POINT SAMSON FORESHORE MANAGEMENT PLAN REVIEW

PROJECT NAME	
Title	Point Samson Foreshore Management Plan Review
Production Date	23rd June 2022
Prepared By	UDLA
Author	Hamish Firth/Katherine Hailstone
Status	FINAL
UDLA Project Code	KARPS

City of Karratha

FIGURE 5. EXTRACT FROM FMP PAGE 26

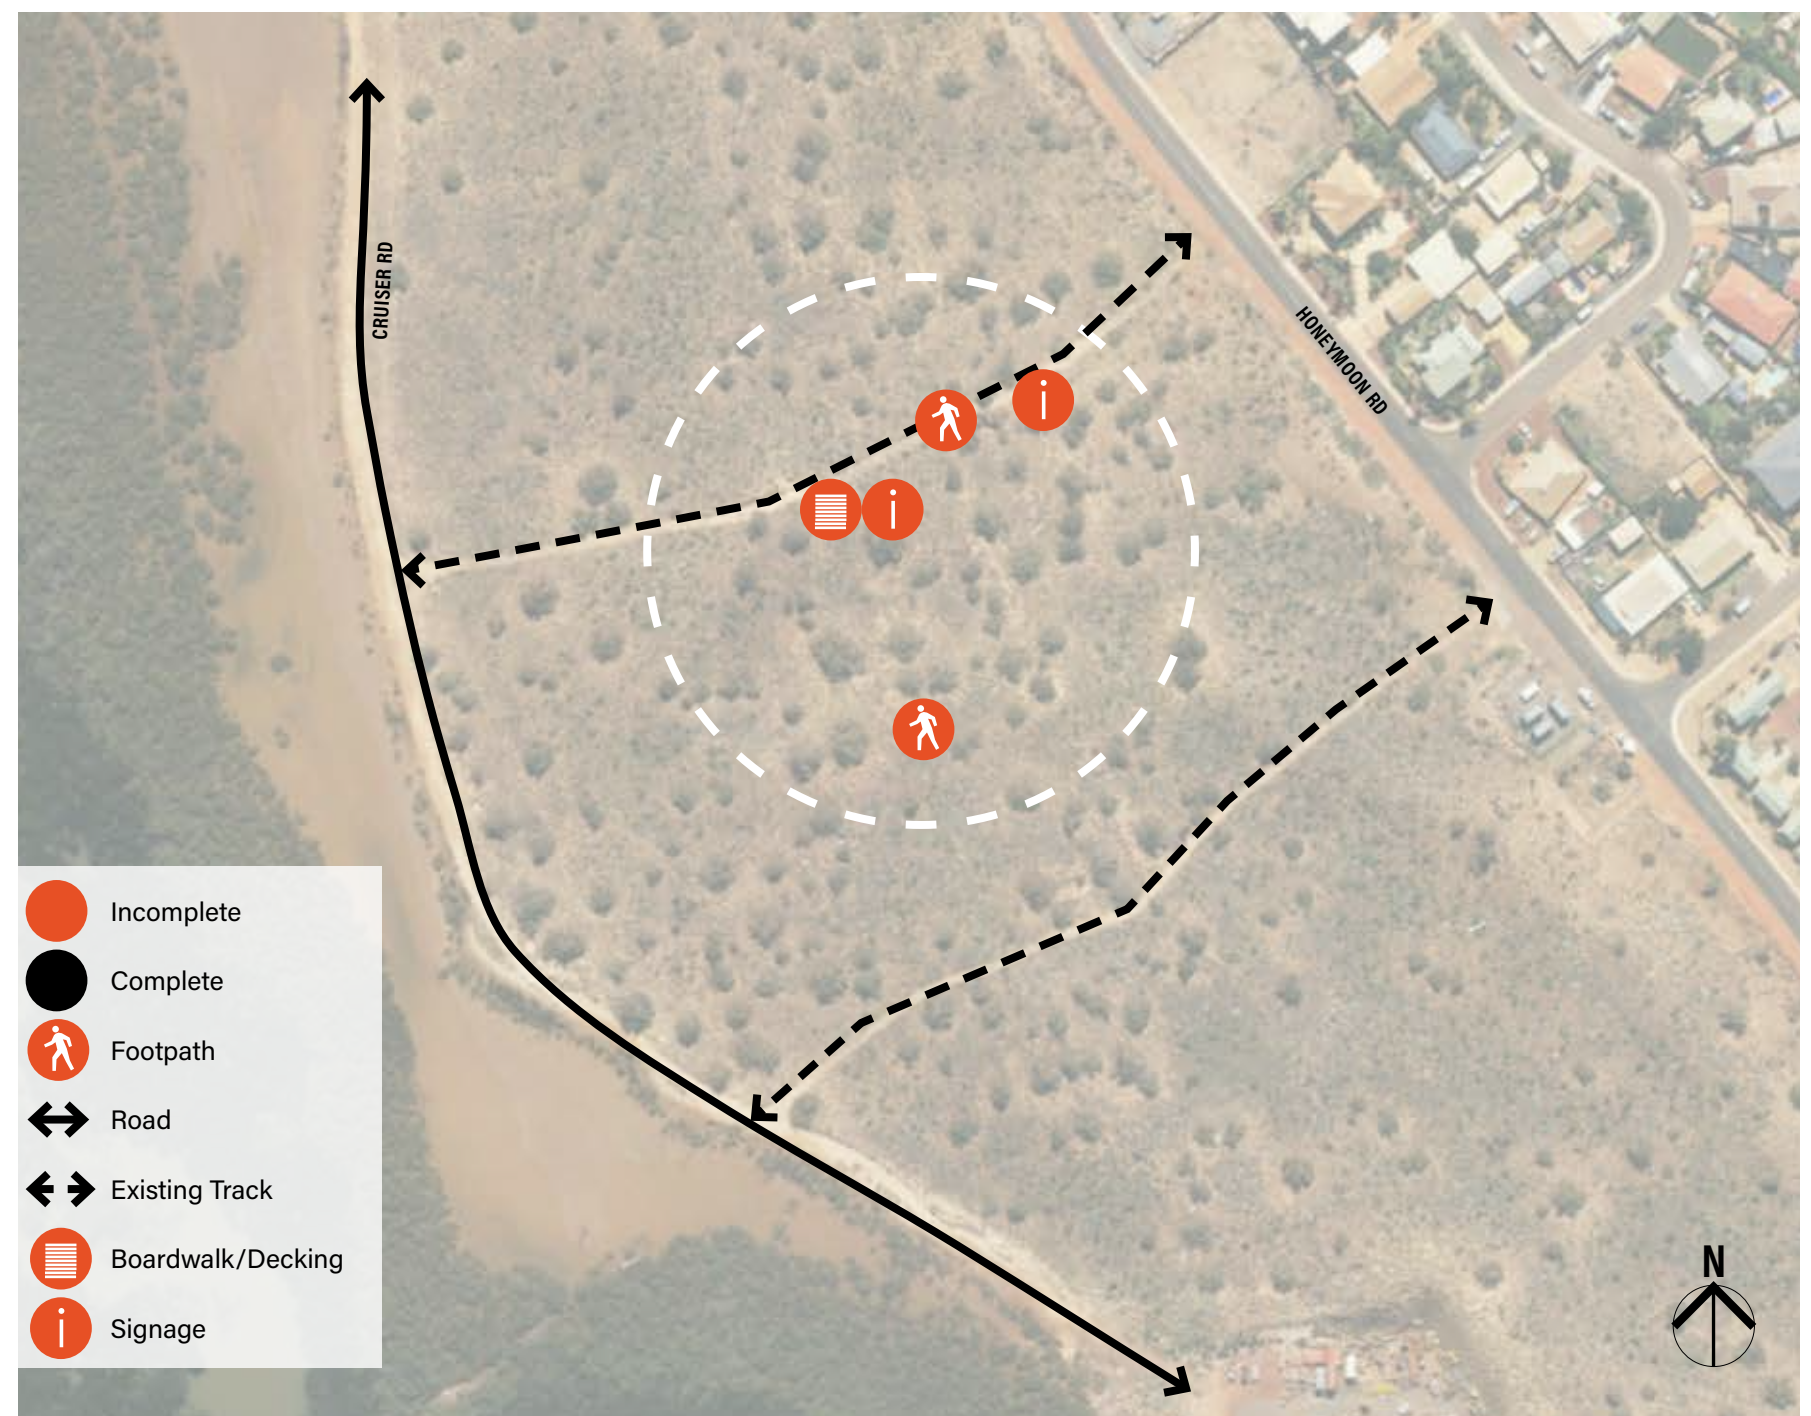
1. Establish Signage identifying historic and environmental values of the area - **INCOMPLETE**
2. Construct lookout with 360 degree views of town sites and mangroves - **INCOMPLETE**

FIGURE 8. AERIAL SOURCE. MNG, MAY 2020

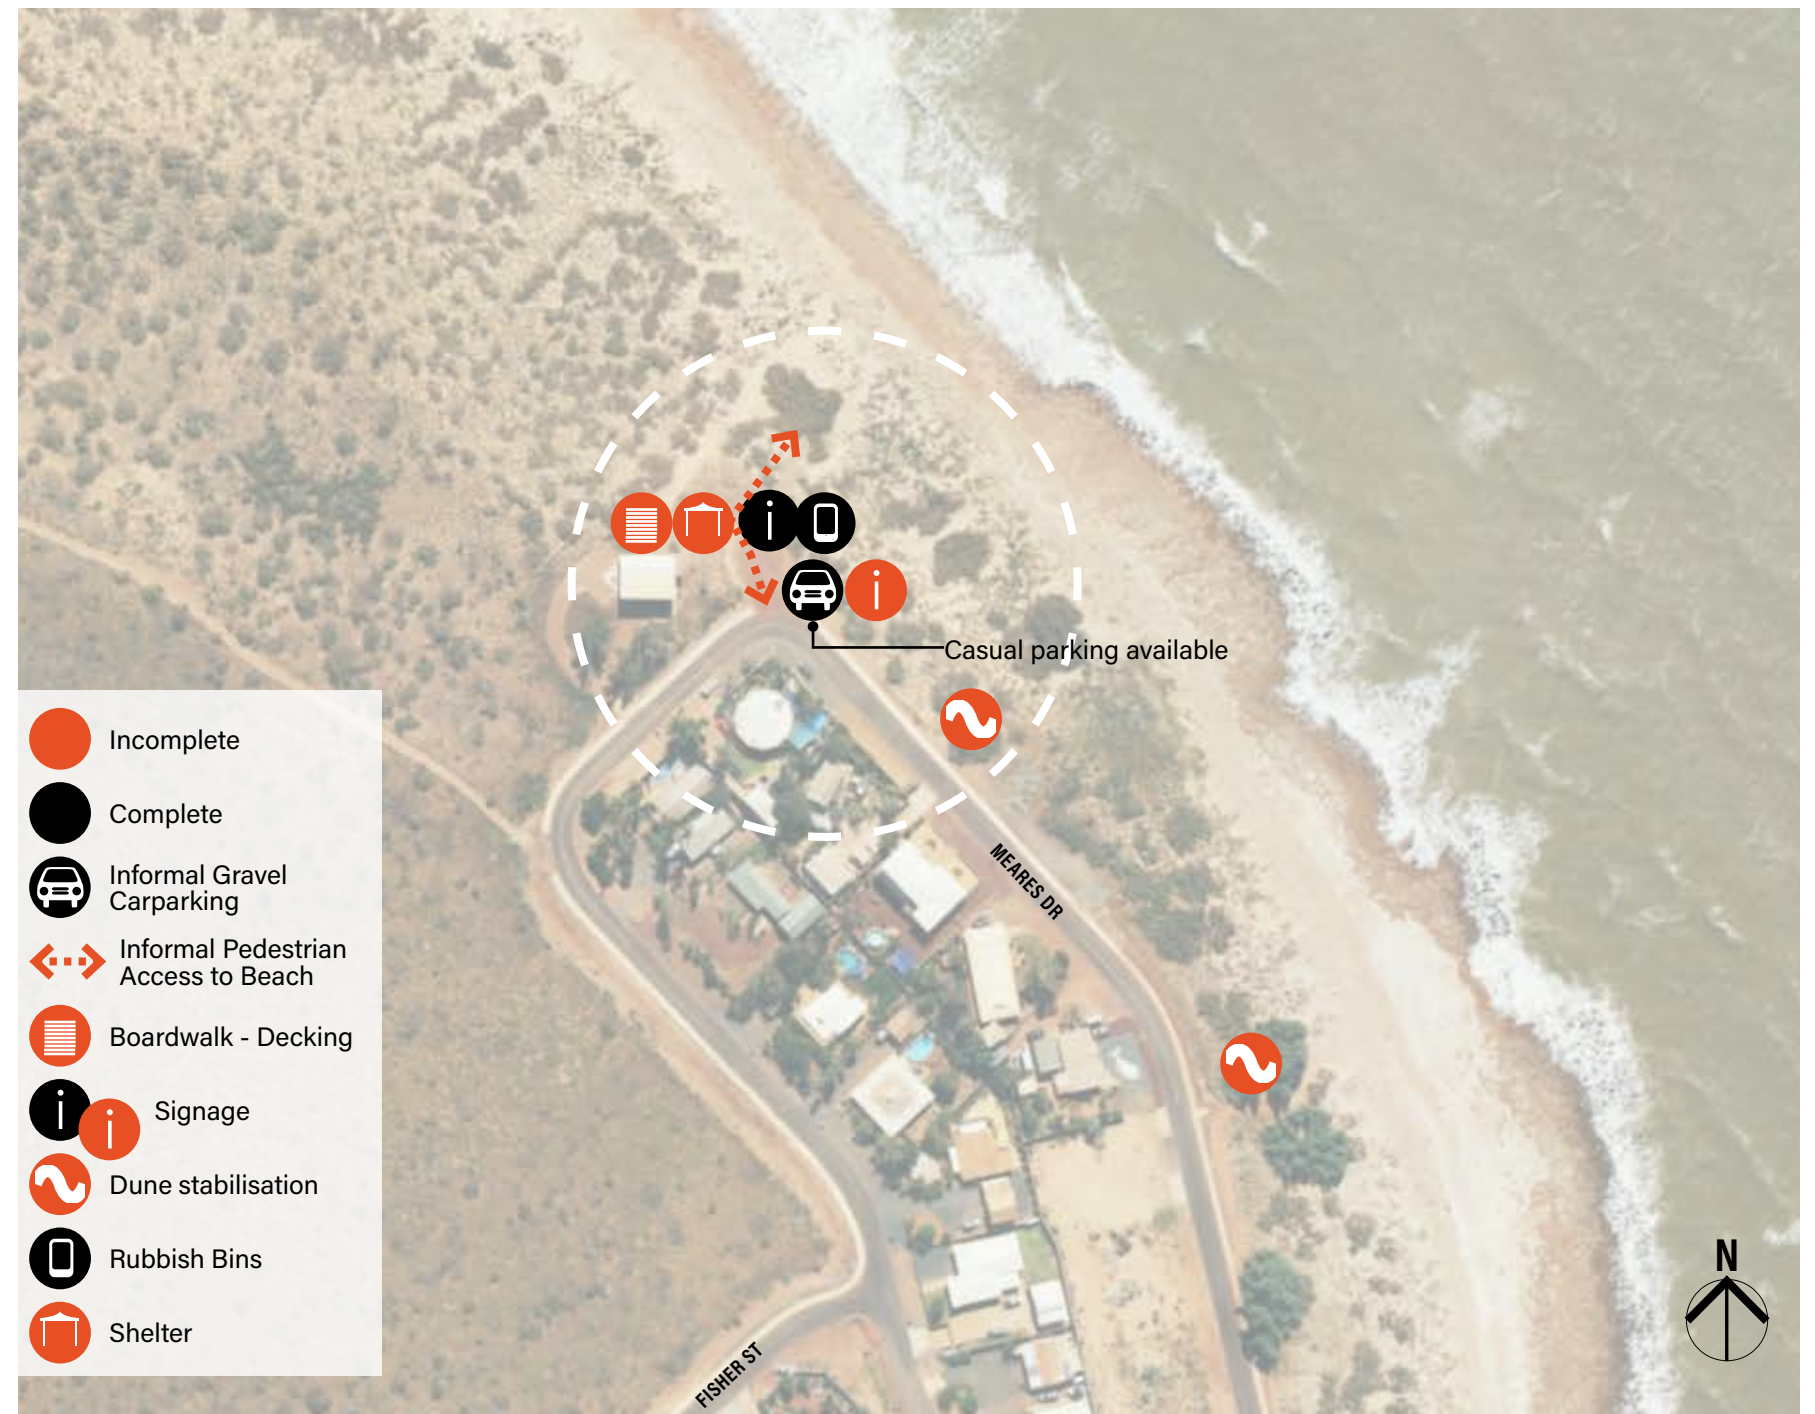
1. Establish signage identifying historic and environmental values of an area - **INCOMPLETE**
2. Undertake dune restoration and revegetation - **INCOMPLETE**
3. Beach access to commence with decked lookout area with shelter and consider prevailing wind and steps as appropriate - **INCOMPLETE**

FIGURE 18. AERIAL SOURCE. MNG, MAY 2020

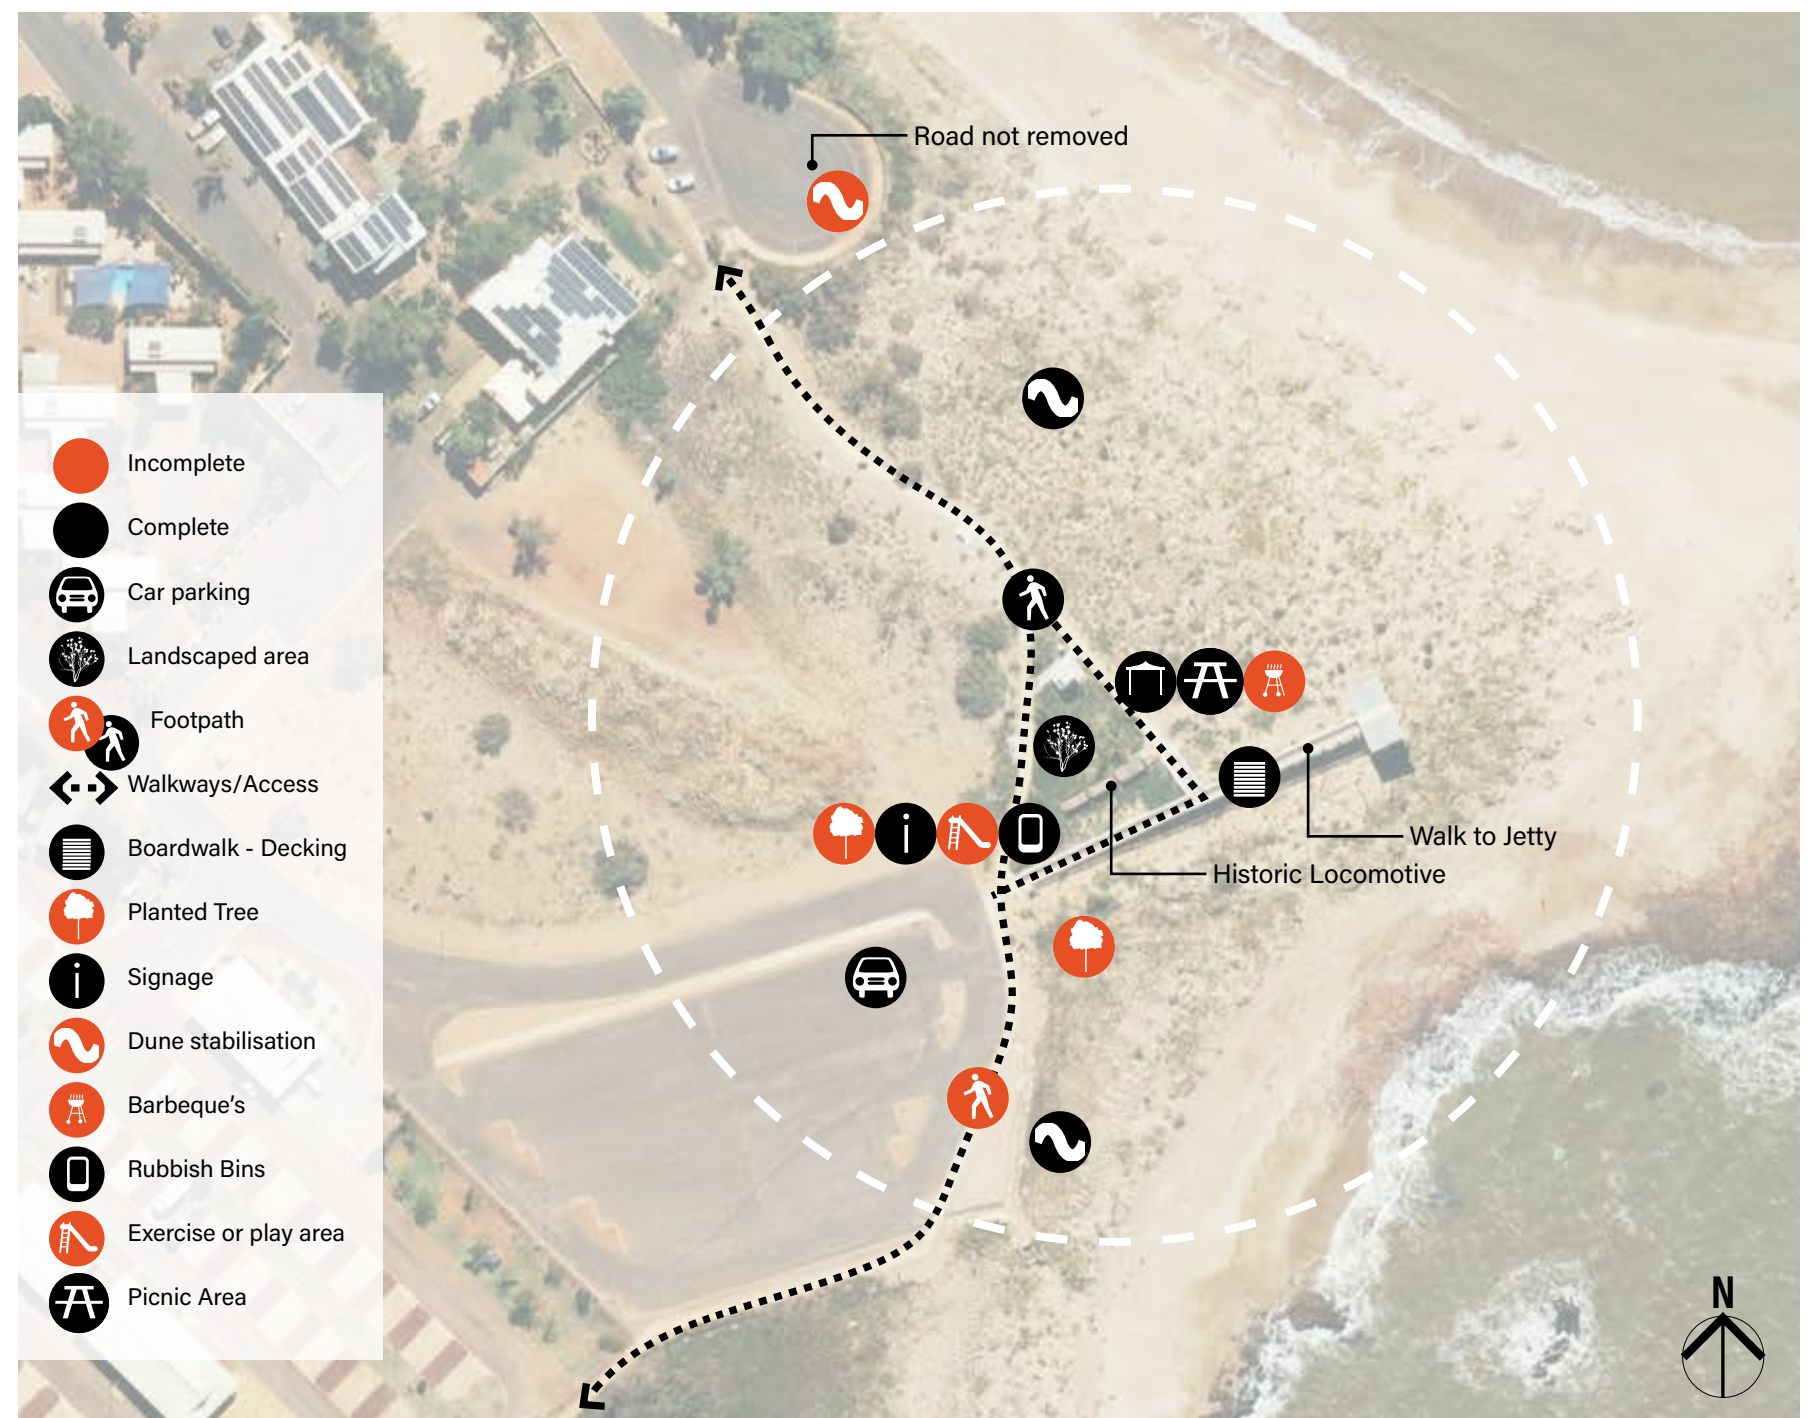
1. Construct feature walk to Jetty with signage - **COMPLETE**
2. Remove existing road and undertake dune restoration and revegetation - **INCOMPLETE**
3. Install sawtooth dune stabilisation structures - **INCOMPLETE**
4. Landscape and tree planting to improve amenity - **COMPLETE**
5. Construct shelter/barbeque area - **INCOMPLETE?**

FIGURE 30. AERIAL SOURCE. MNG, MAY 2020

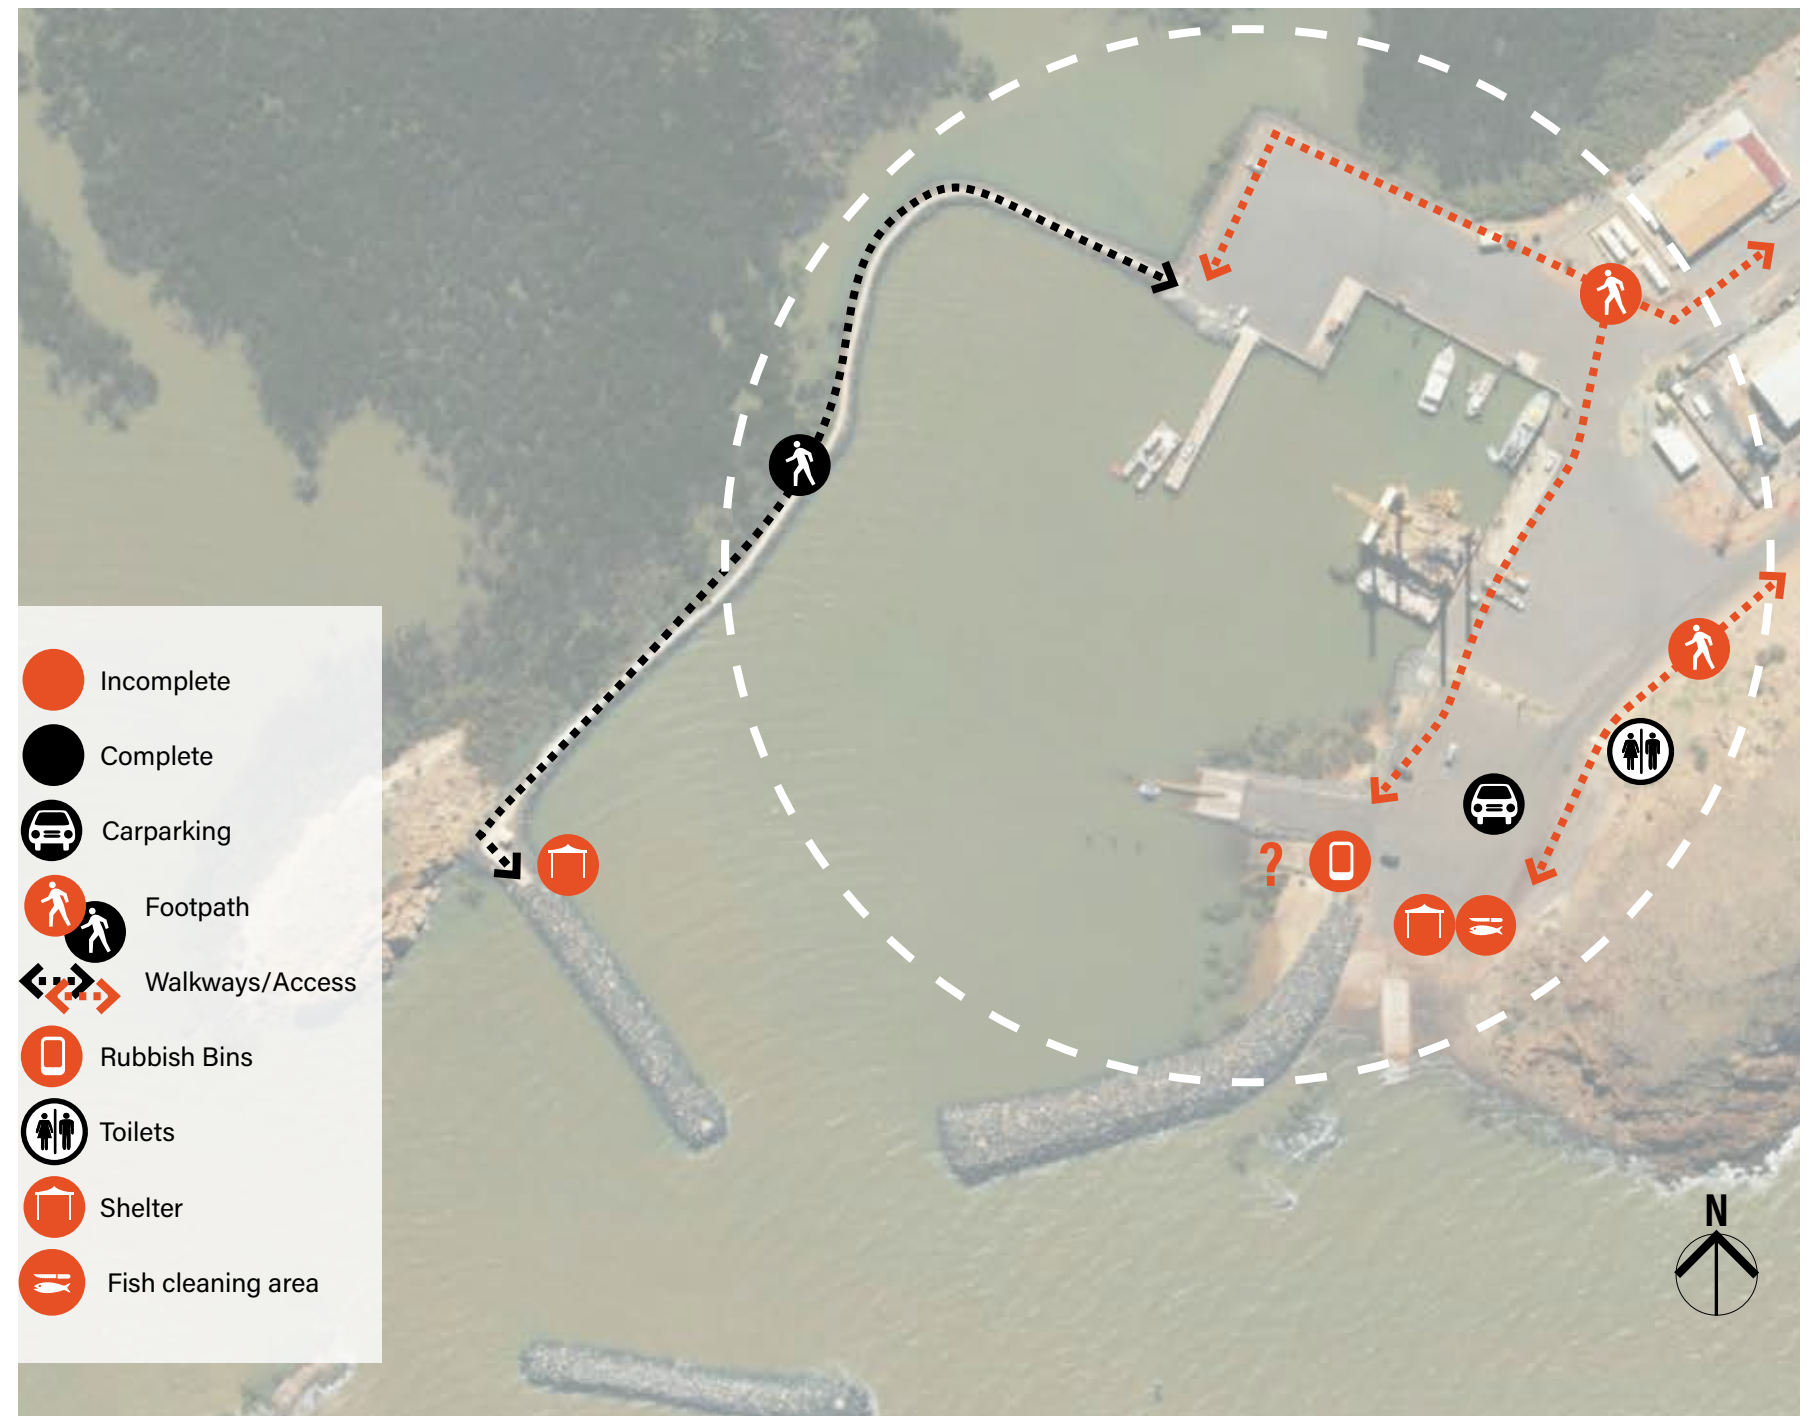
1. Provide safe marked footpaths through harbour area - **INCOMPLETE**
2. Construct fish cleaning facilities - **INCOMPLETE**
3. Retain existing toilets, shelters and bins - **PARTIALLY COMPLETE, (PLEASE ADVISE CONDITION)**
